Form C-103

WELL API NO. 30-025-01441
5. Indicate Type of Lease STATE ☒ FEE ☐
6. State Oil & Gas Lease No.
7. Lease Name or Unit Agreement Name CAPROCK MALJAMAR UNIT
8. Well Number #004
9. OGRID Number 329487
10. Pool name or Wildcat [43329] MALJAMAR;GRAYBURG-SAN ANDRES
4. Well Location Unit Letter C : 660 feet from the North line and 1980 feet from the West line Section 17 Township 17S Range 33E NMPM LEA County
11. Elevation (Show whether DR, RKB, RT, GR, etc.) 4203' GL

SUNDRY NOTICES AND REPORTS ON WELLS
 (DO NOT USE THIS FORM FOR PROPOSALS TO DRILL OR TO DEEPEN OR PLUG BACK TO A DIFFERENT RESERVOIR. USE "APPLICATION FOR PERMIT" (FORM C-101) FOR SUCH PROPOSALS.)

Action 77326

CAPROCK MALJAMAR UNIT #4**660' FNL & 1980' FWL, UL C, Sec 17, T17S, R33E, Lea County, New Mexico**

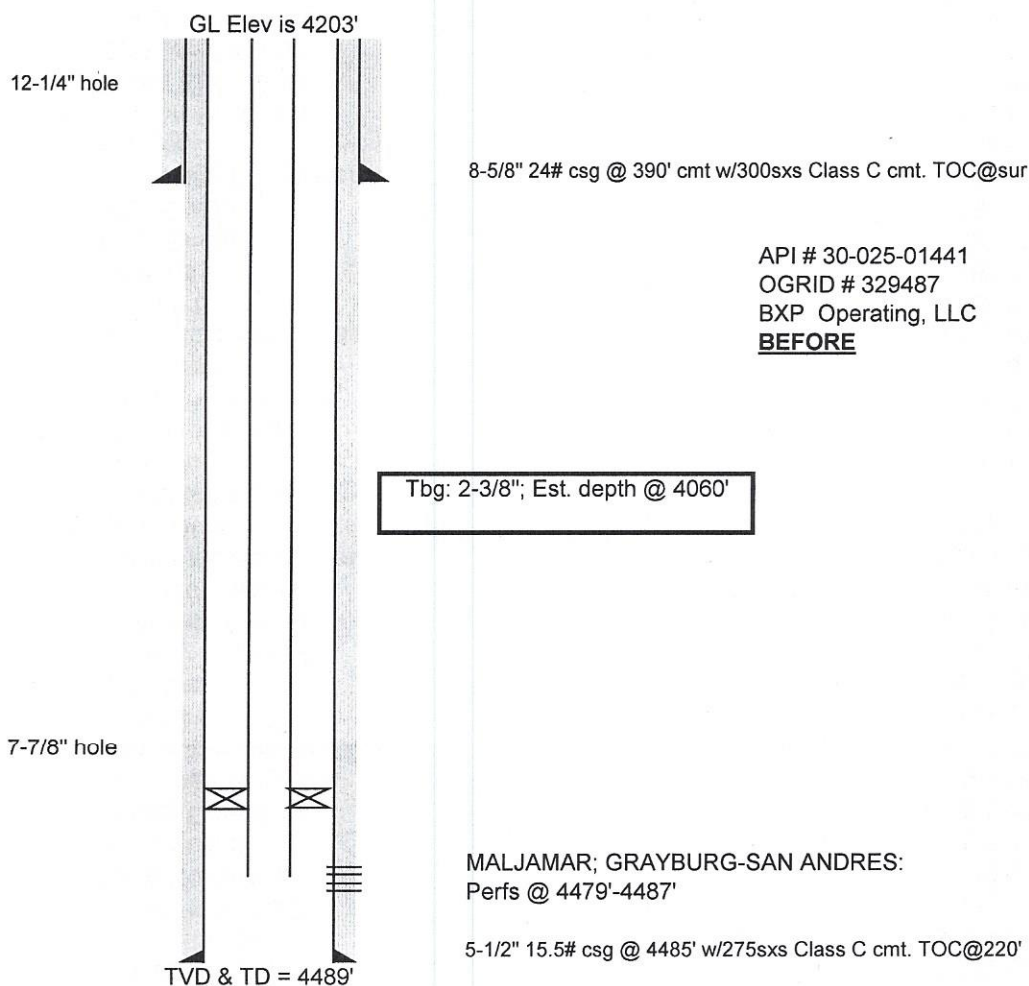
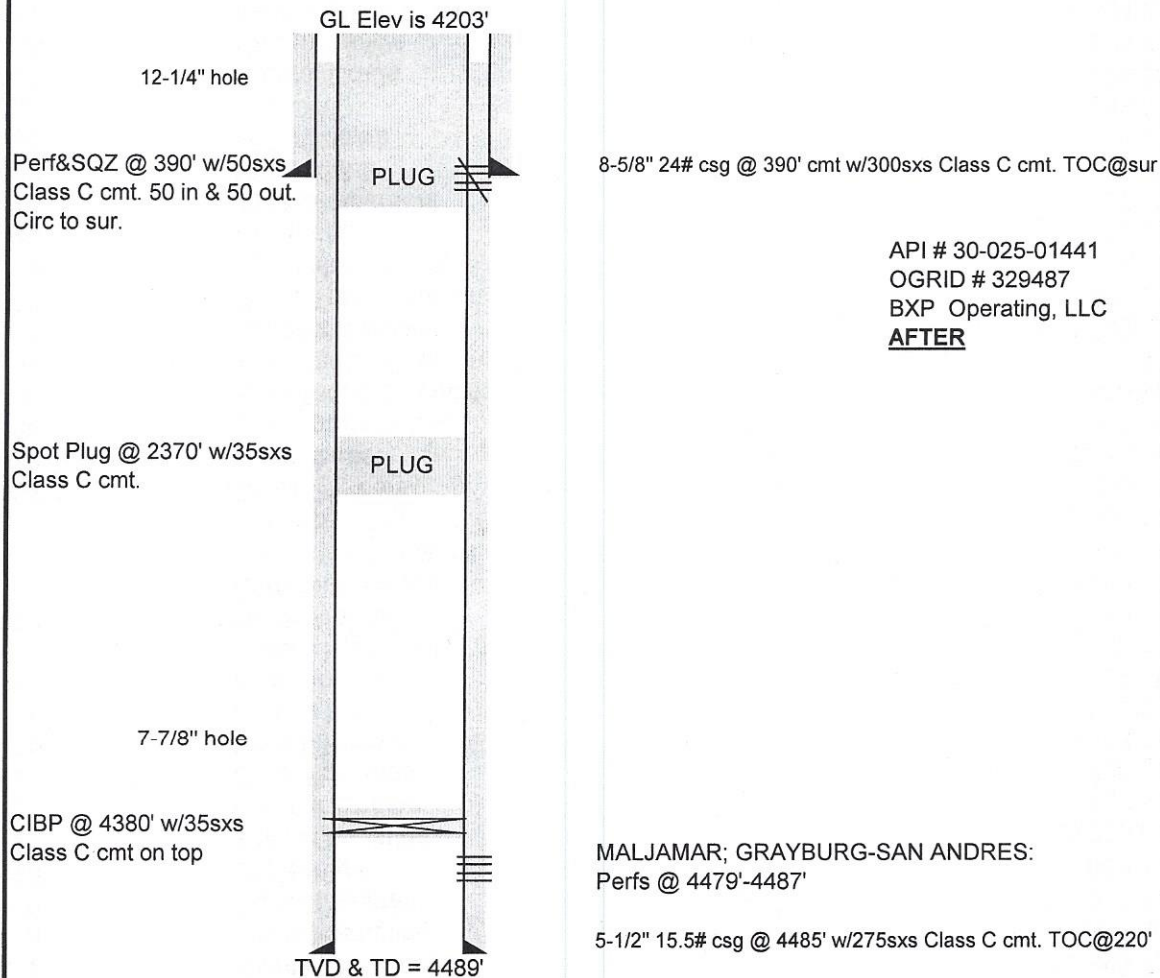
Note changes to procedure

4" diameter 4' tall Above Ground Marker
